# PERMIT

SEWAGE DISPOSAL SYSTEM

SUBDIVISION Brantwood

LOT 23 BRANTWOOD

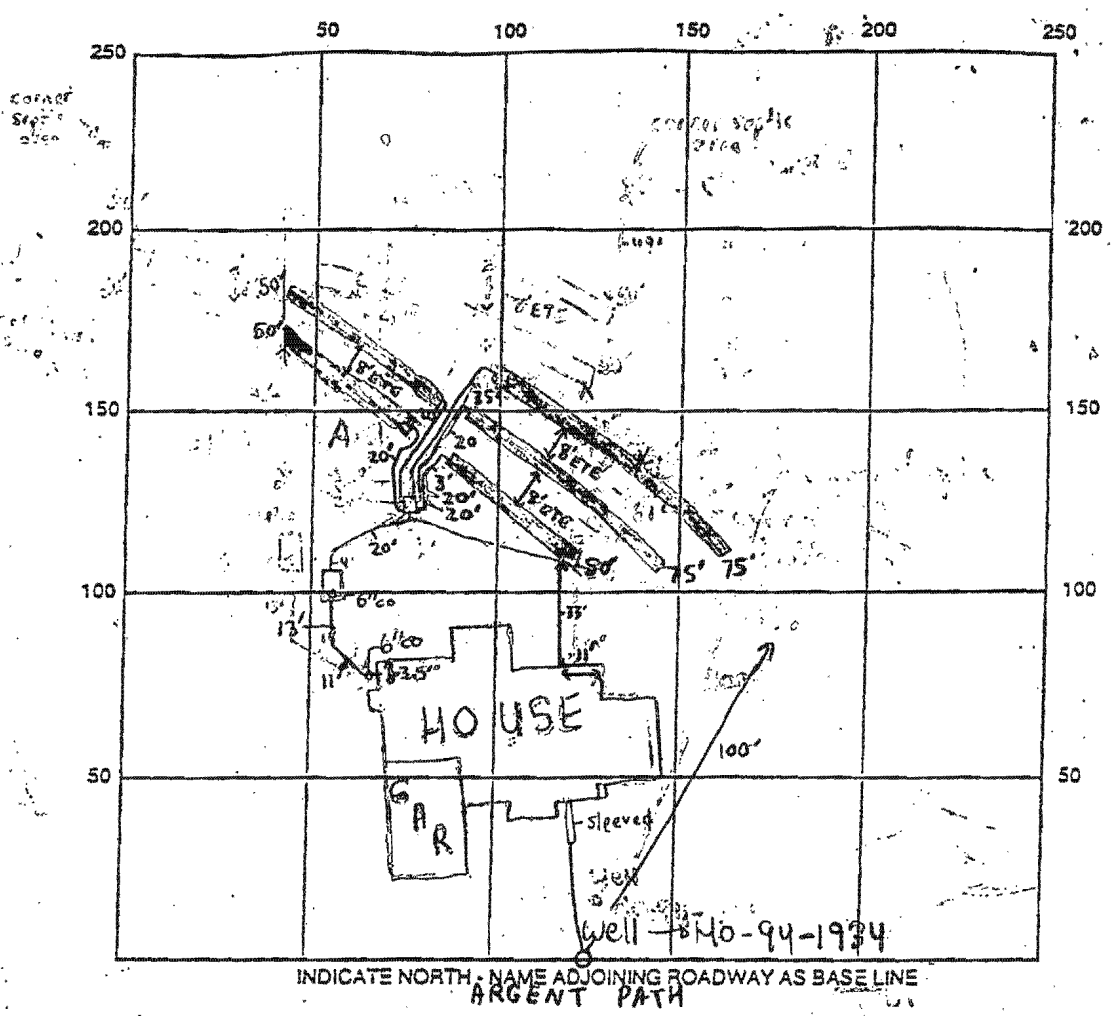
REMARKS: 12/20/99 - WELL CASING WILL NEED TO BE EXTENDED TO OBTAIN 8" ABOVE FINISHED GRADE, HOUSE CONNECTION NEEDED, OK TO CONTINUE WORK, SEPTIC AREA IN LOCATION A WAS NOT UTILIZED BUT CAN BE IN THE FUTURE

(SRW) 12/21/99 - WPZ OK - ISSUES RESOLVED, HOUSE CONNECTION MADE, OK TO COVER ALL WORK (SRW)

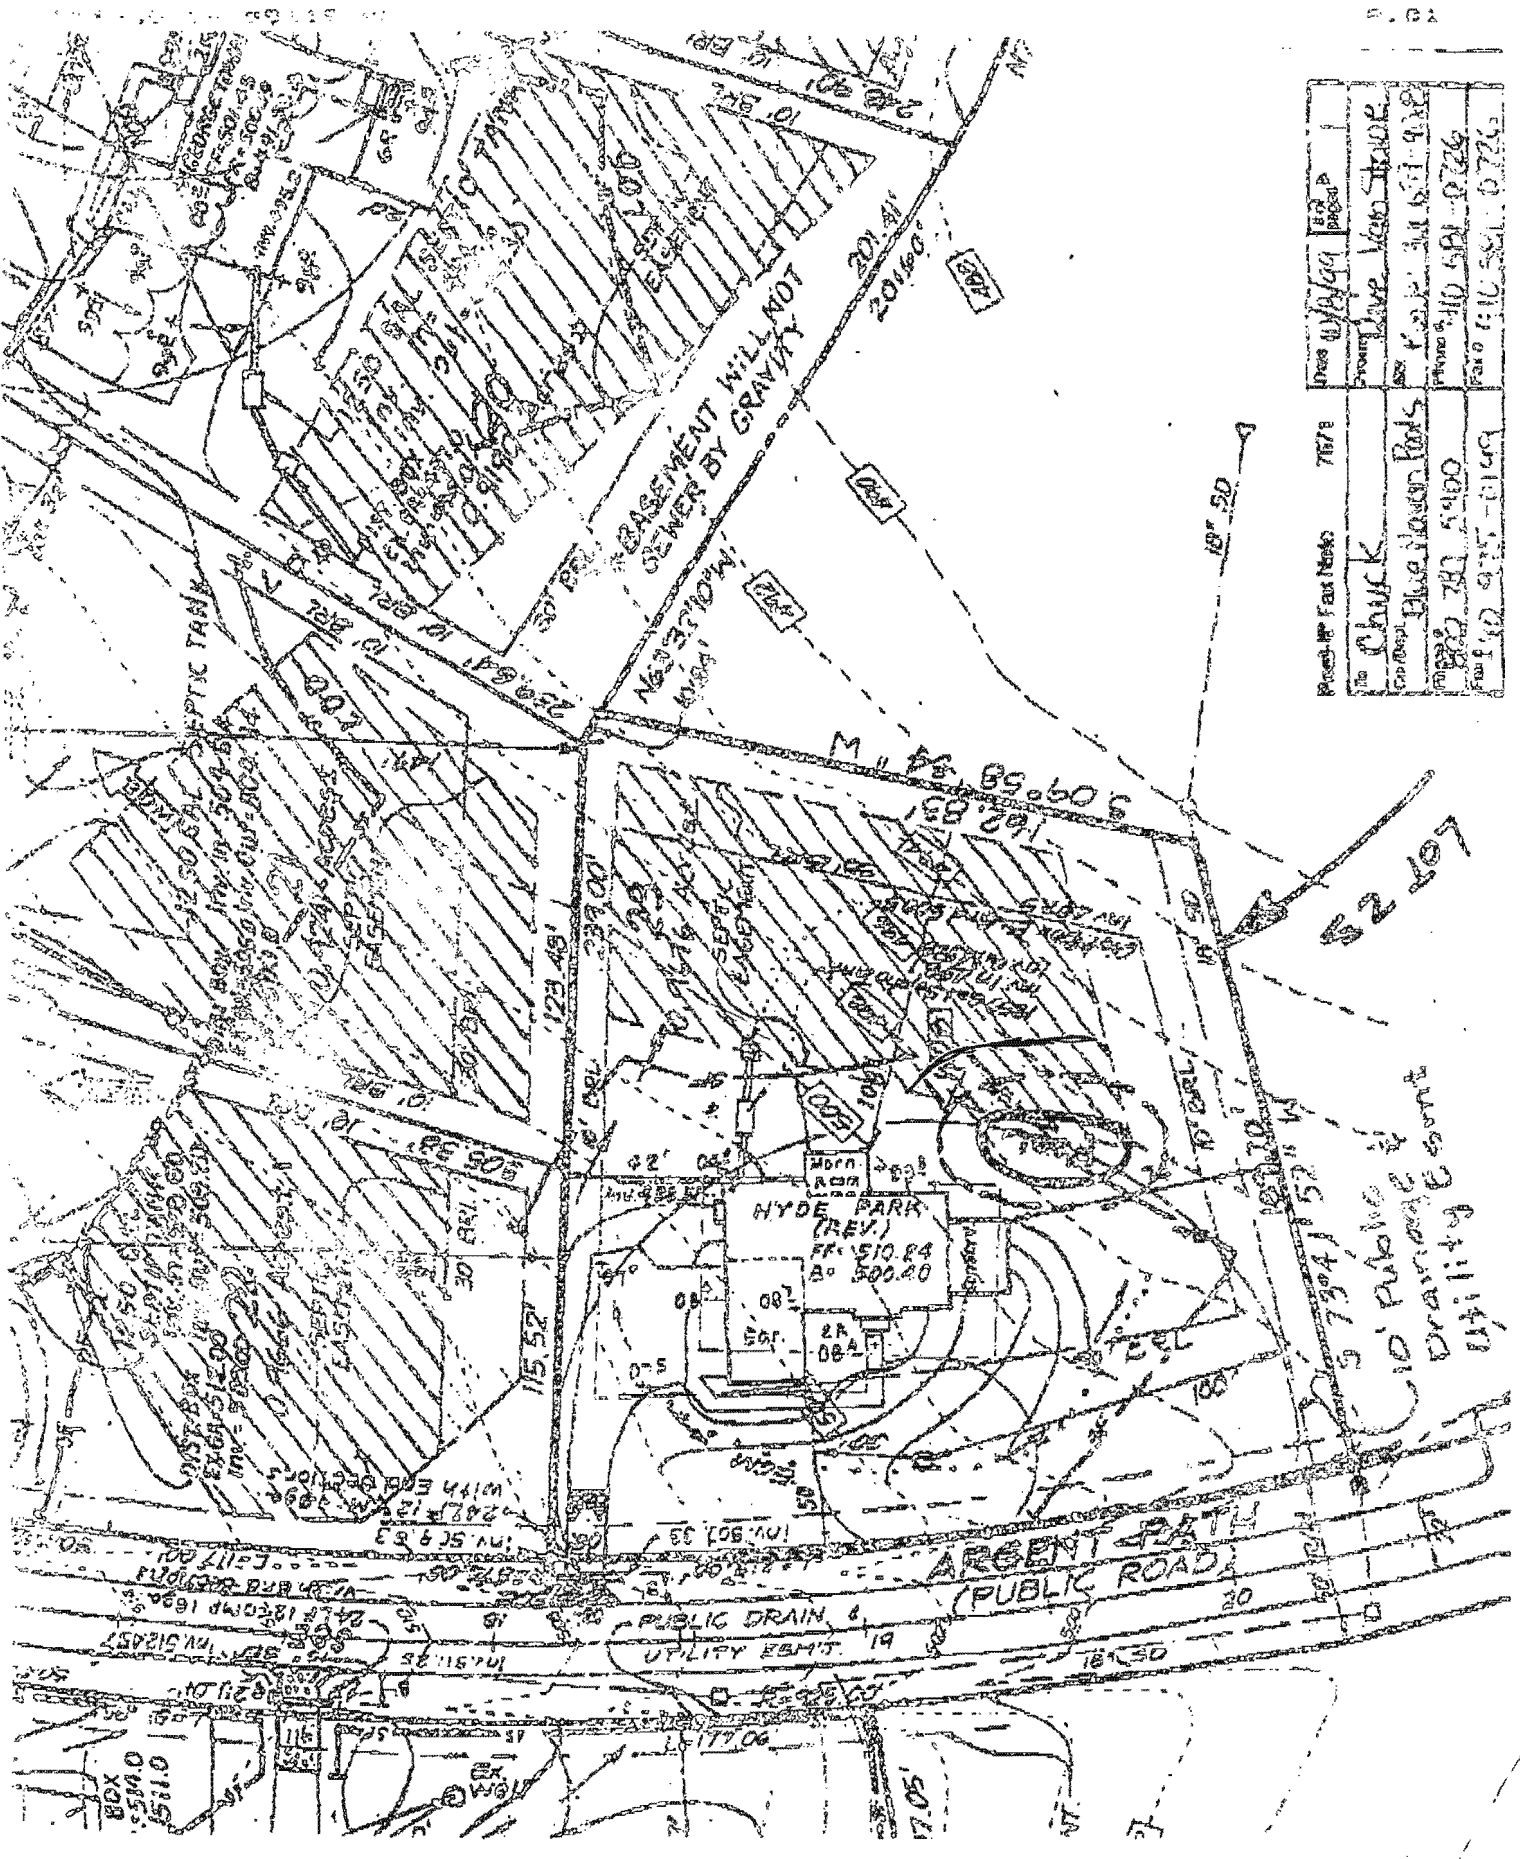
THIS LIMITED POOL INTRUSION CAN BE MADE UP ON LEFT SIDE OF LOT.

WILL BE BACK WITH SPECIFIC PLAN

BE SURE HOUSING FOOTPRINT MATCHES BR PLAN NO ADDITIONAL SEPTIC AREA CAN BE LOST.

NO SEPTIC MAKE-UP SHOULD BE IN THIS AREA (TEST HOLES FRICED FOR WATER TABLE)

# Pool Context Plan

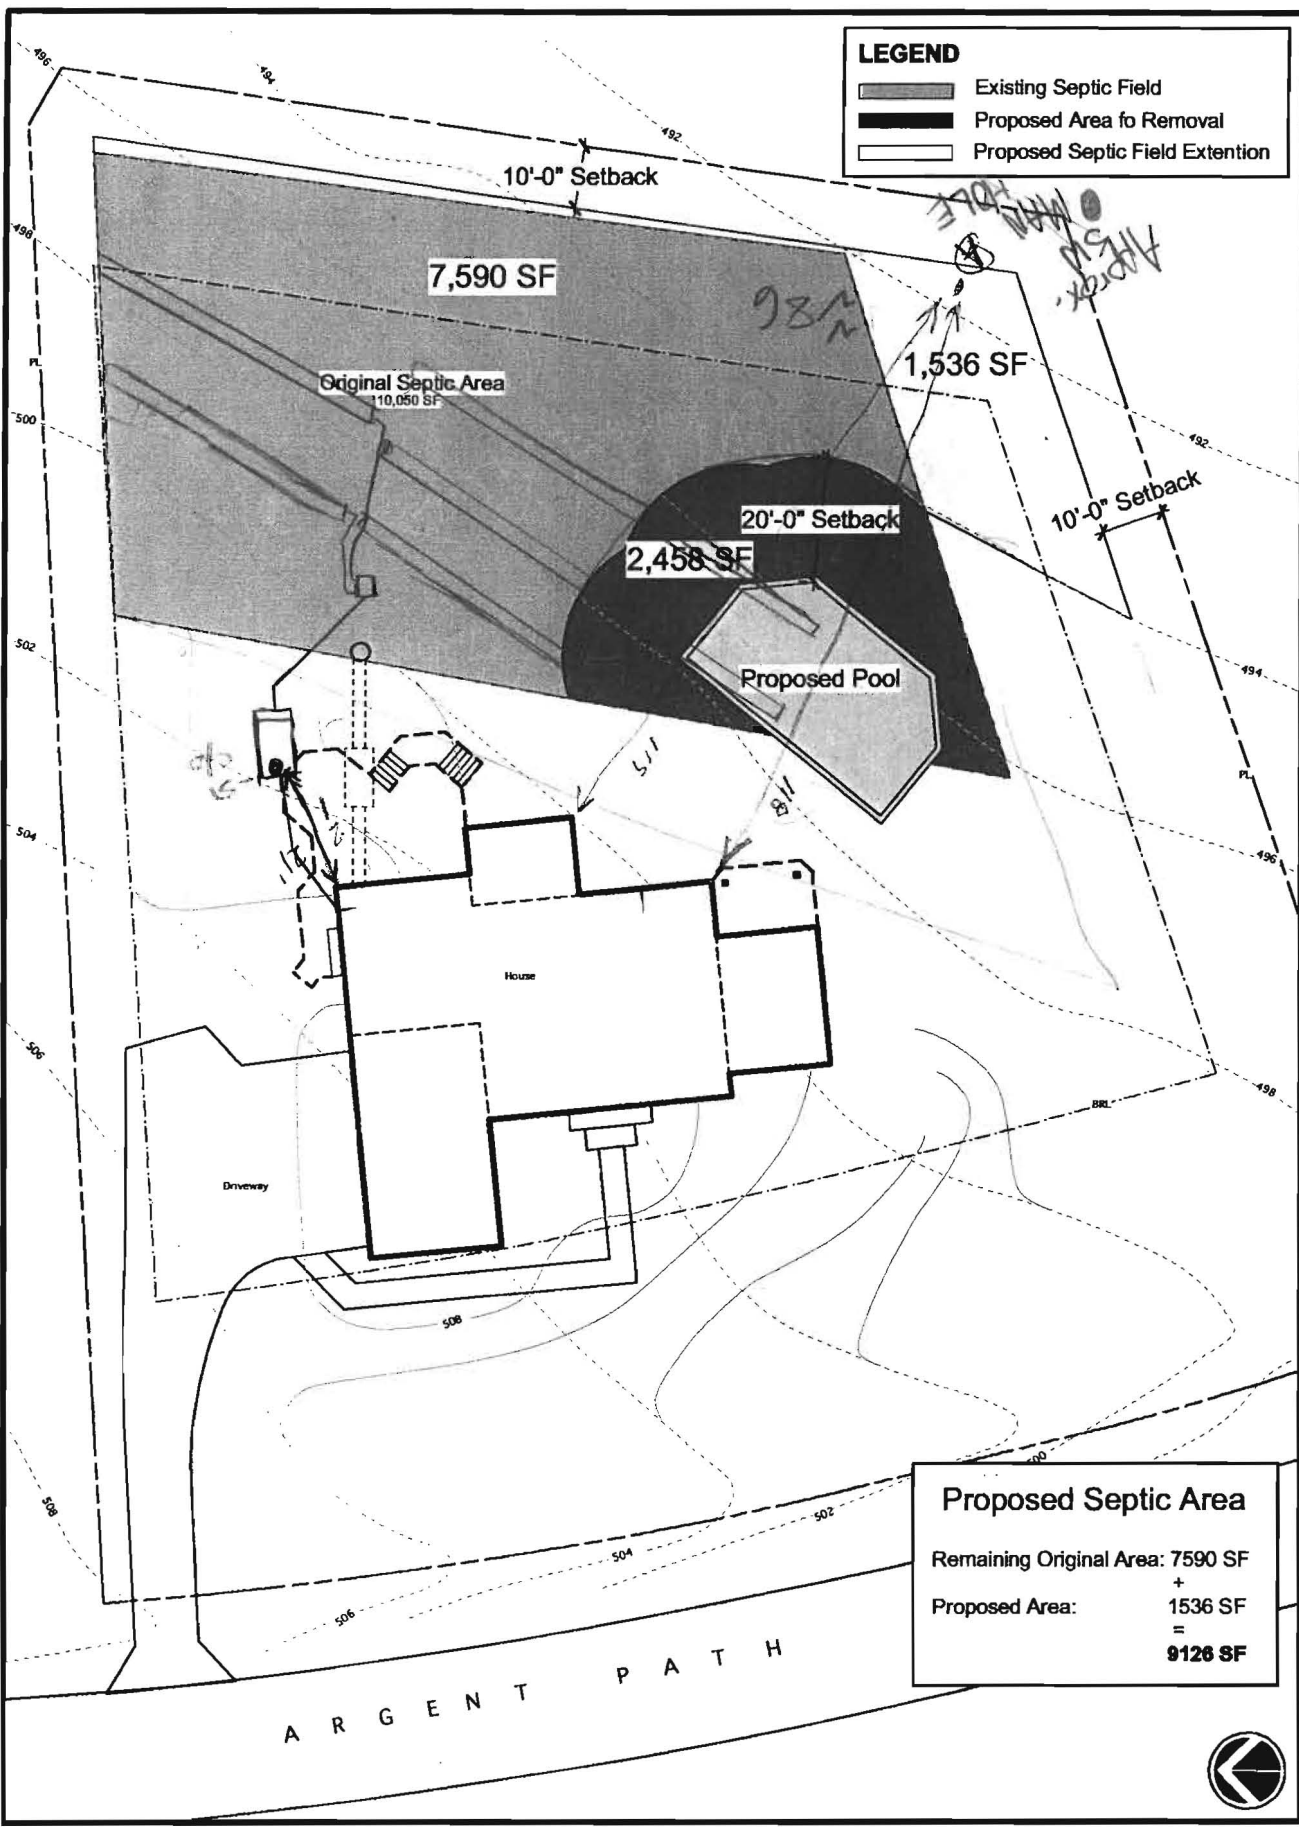
Remaining Original Area:	7590 SF
+	
Proposed Area:	1536 SF
=	
	<b>9126 SF</b>
